Access Compliance Report

Public Rights-of-Way (Curb Ramps)

Intersection ID: 10020275	Main Street: AYRSLEY_TOWN_BV	Cross Street: N/A	Location: SE
ADA ID: 1E954A945CEF	Ramp Type: BlendTrans1	Initial Pass/Fail: Pass	Overall Compliance: No
Severity Score: 0			
Codes/Mitigation Info/Possible Solution		Field Measurements/Component Compliance

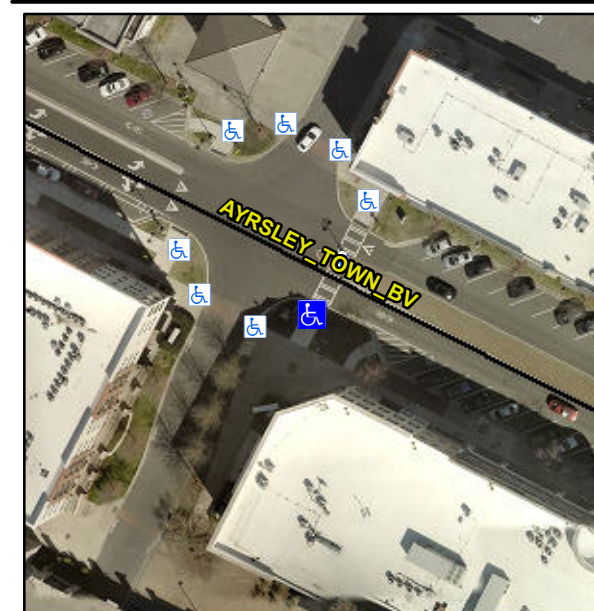
Remove & Replace Curb Ramp With Two New Directional Ramps or Equivalent. Remove & Replace Gutter.

Not Found, R305.2, R304.5.3
